WURLITZER SERVICE SLANT

Fluorescent lamp wiring on all Model 3600, 3660 and 3610 Phonographs shipped from the factory prior to the following serial numbers:

Figure 1. Upper Door Assembly - Left Hand

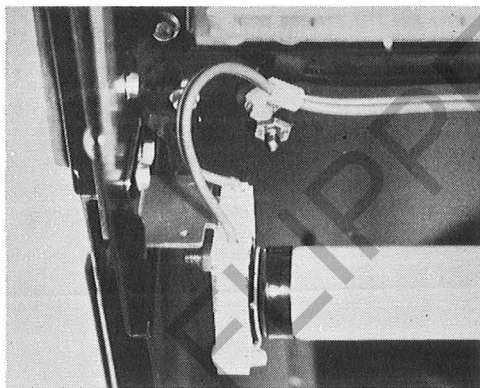
Fluorescent lamp wires being pinched by cable clamps causing separation of insulation.

Inspect the areas shown in Figures 1 through 4 and verify that wires are not pinched by CABLE CLAMPS. If wires are pinched, perform the following:

- Loosen CABLE CLAMPS shown in Figures 1 through 4 and inspect insulation.
- If insulation is broken or separated, tape with plastic electrical tape and reinstall CABLE CLAMP making sure that wire is properly positioned in CABLE CLAMP to prevent pinching.
